**VILLAGE OF GERMANTOWN**  
N112 W17001 MEQUON ROAD  
GERMANTOWN, WI 53022

| MEETING:       | <b>PLAN COMMISSION</b>                    |

# REZONING, CONDITIONAL USE PERMIT APPLICATIONS & SITE PLAN REVIEW

**To :** Jeffrey W. Retzlaff, AICP, Planning Director/Zoning Administrator  
**From :** John Laning, P.E., Village Engineer  
**Date :** October 13, 2017  
**Re :** Discount Ramps –Site Plan Review

**GRADING PLAN**

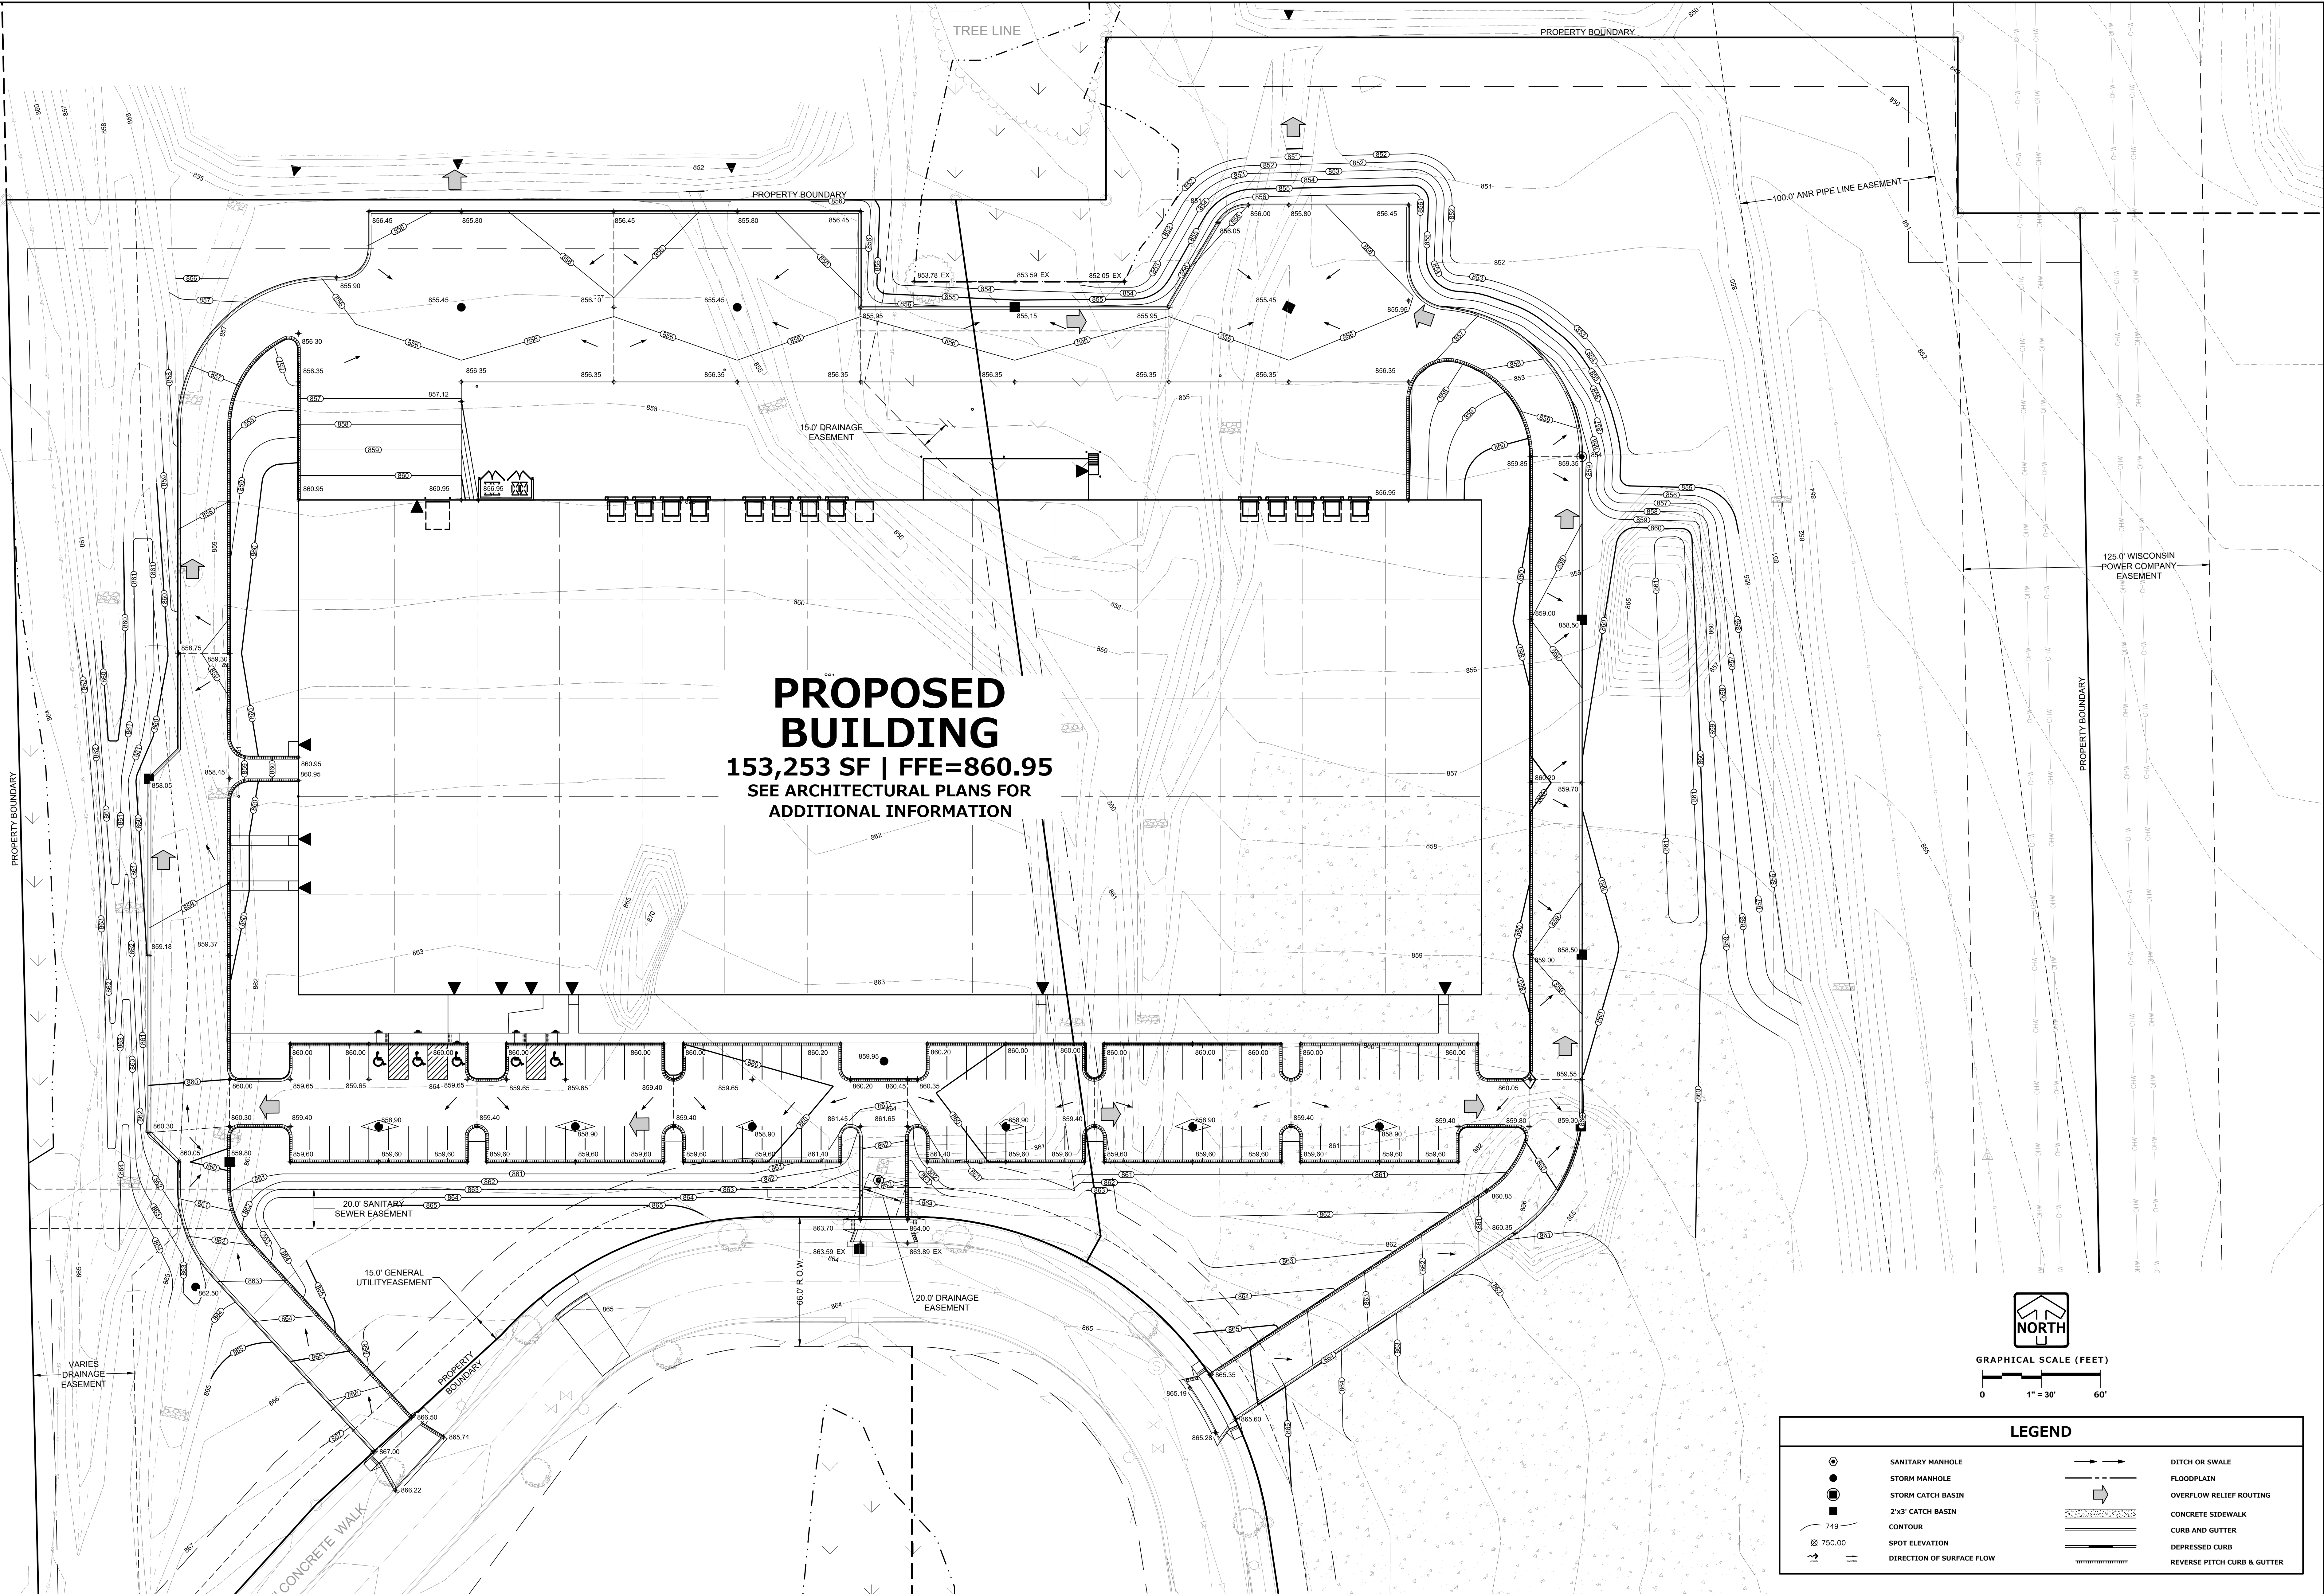
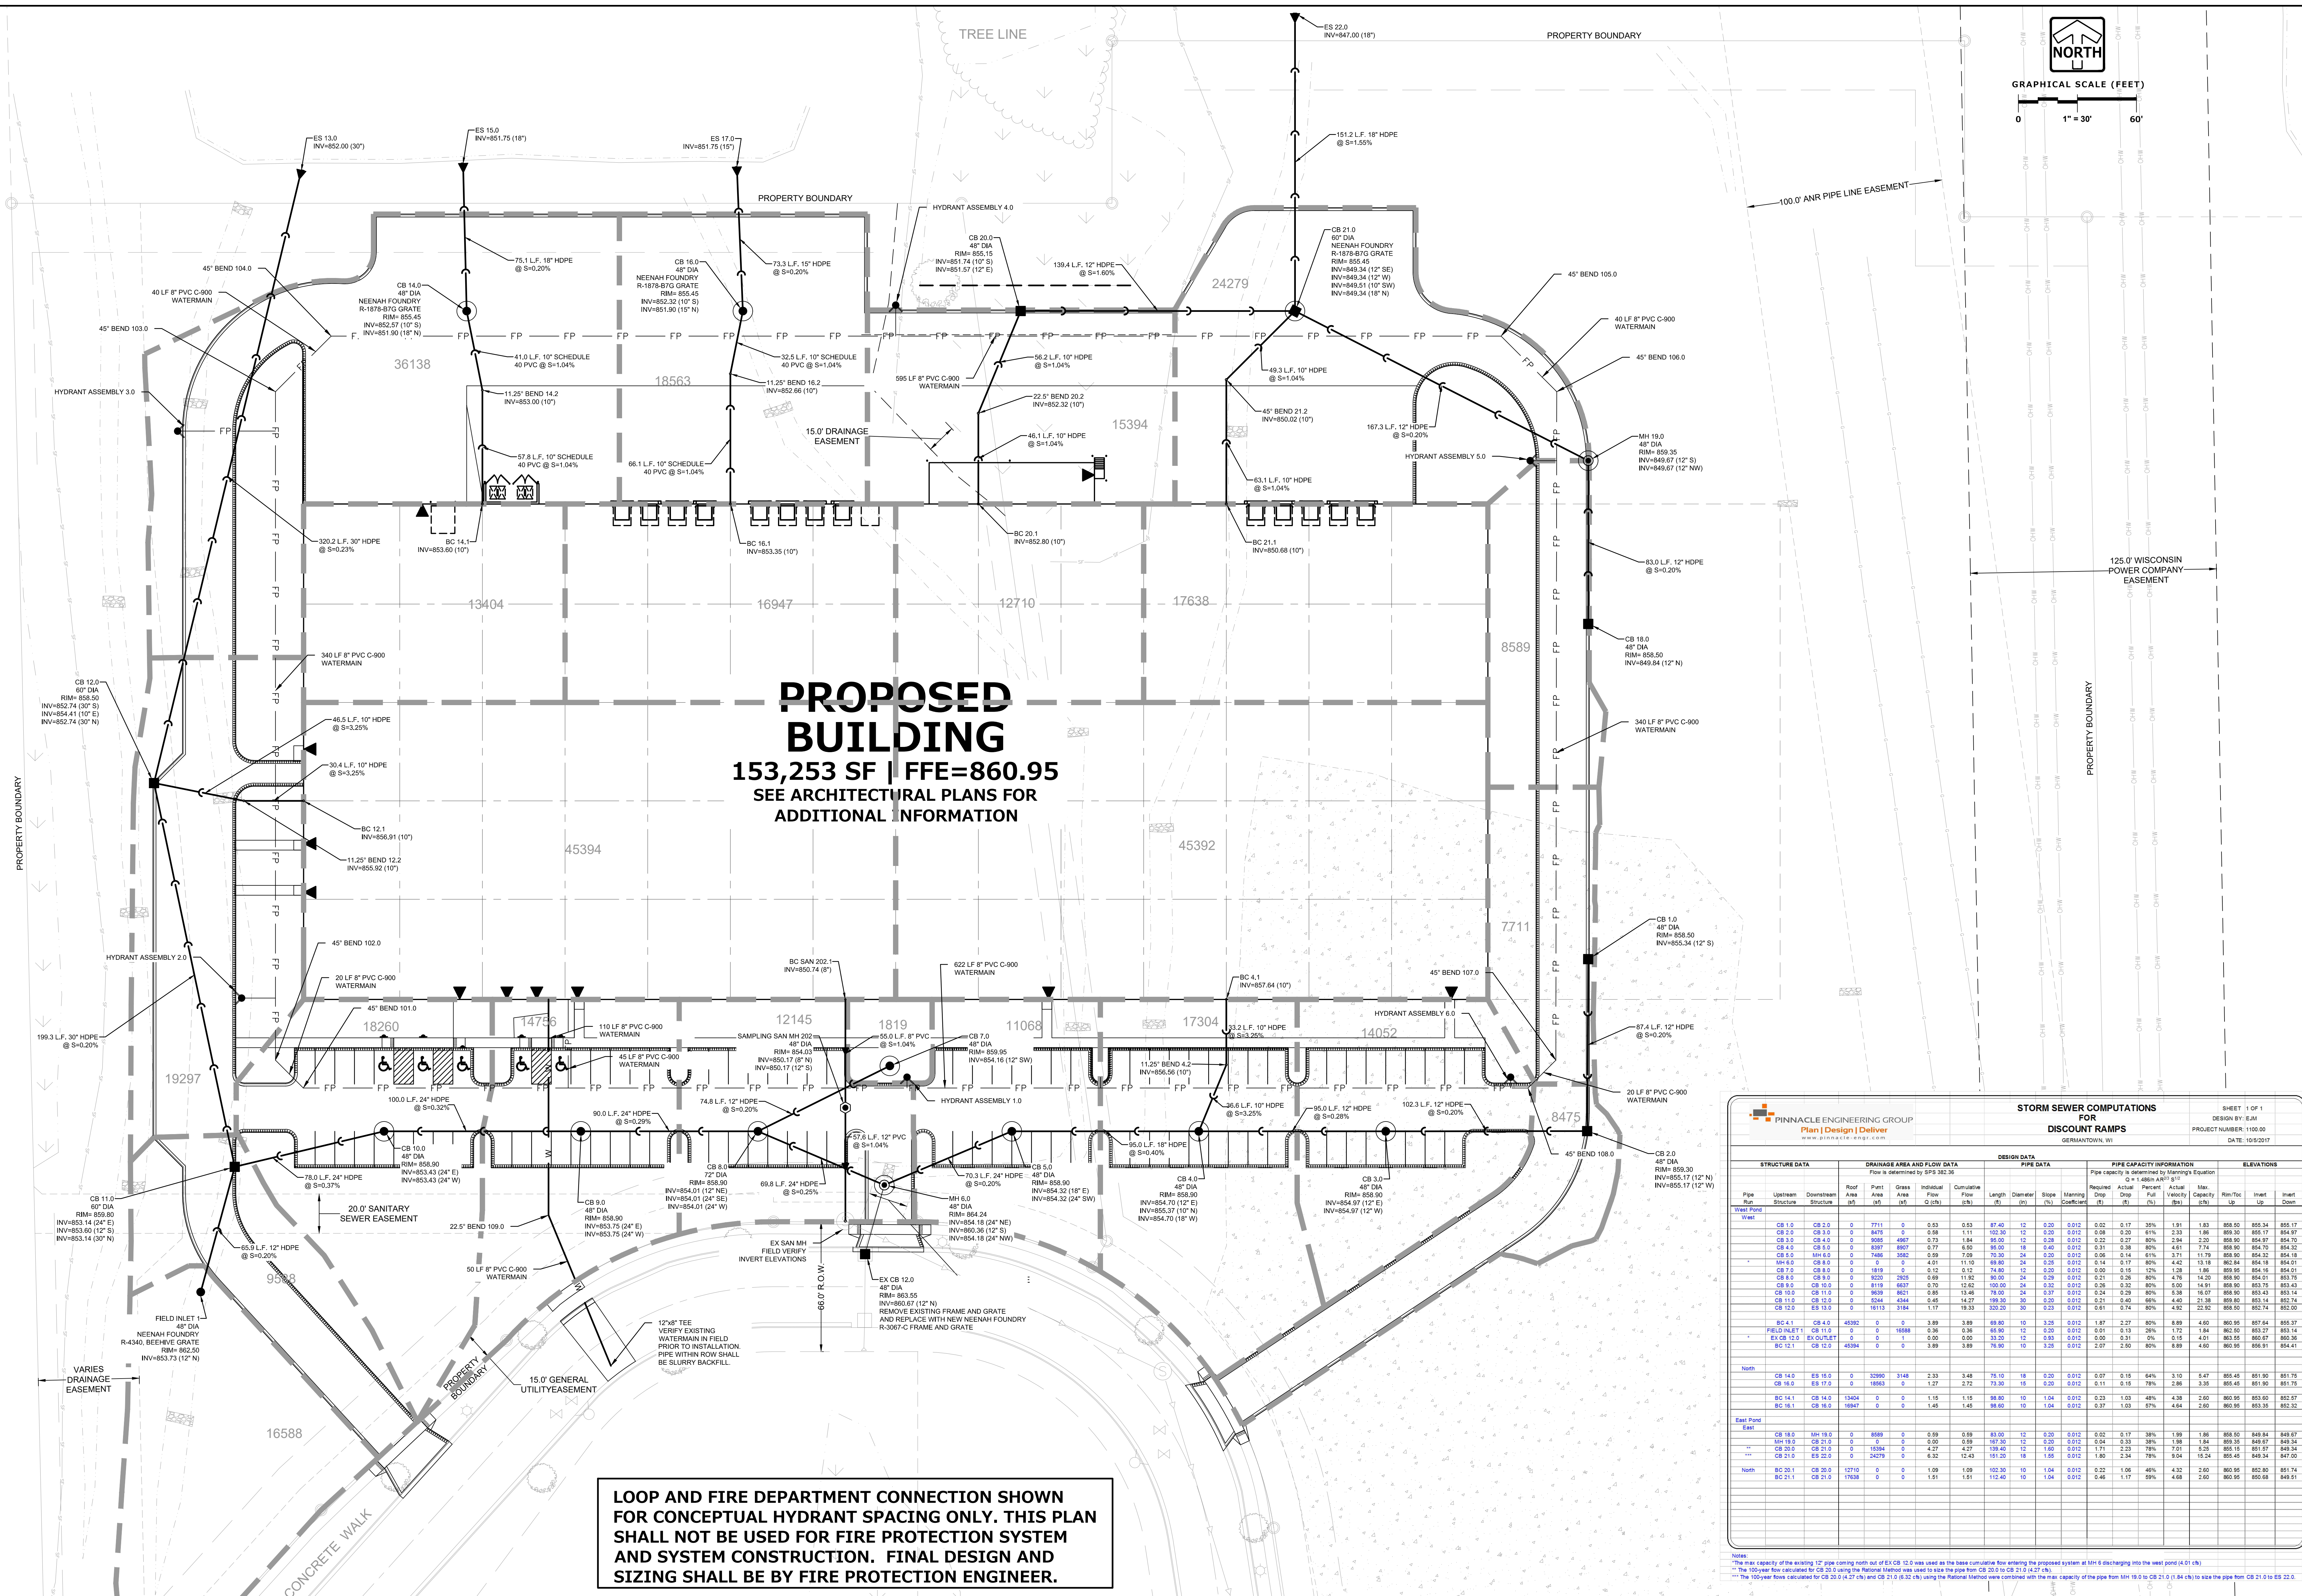
1. Based on proposed grades, overland flow will overtop the curb to the north and bypass the existing stormwater basin instead of overtopping to the east as indicated by the arrow. Adjust grading to have overflow routed to the existing stormwater basin and match the intended overflow arrow.

2. Show and label wetland setbacks as well as wetland buffer disturbance areas.
3. Add additional grade information to the loading dock area to clarify grades. Show grades at the bump out in the center of the building and at the bottom of the stairs.
4. Install new permanent ditch checks in the swale on the west side of the site to replace the existing ones.
5. Bypass swale on the west side of the site is being made narrower and shallower. Provide calcs showing that it can still safely pass the tributary flow from the 100 year storm event without overtopping.
6. It appears the top of curb will be higher than the door elevation on the west side of the building. Add spot grade information to clarify how this will work.

7. Add additional spot grade information to the main entrance area. Clarify how curb ramp will work with concrete to the north. Will there be a step here?

8. Add ground grades and sidewalk grades around the entire building perimeter. Based on curb grades shown it appears some areas between the sidewalk and building will be very flat or need to have the ground grade higher than the finished floor. (example at south of building in image)

9. It appears some contours are missing in this area on the southwest side of the site.

10. Grading plan will create over a foot of ponding prior to overtopping for the area south of the ADA parking. Revise grading plan to allow for a maximum of 6" of ponding in parking areas.

12. Add label for NWL for the two stormwater basins.

13. Show existing wetland location and add note that no disturbance or work shall take place in the wetland prior to obtaining a wetland fill permit.
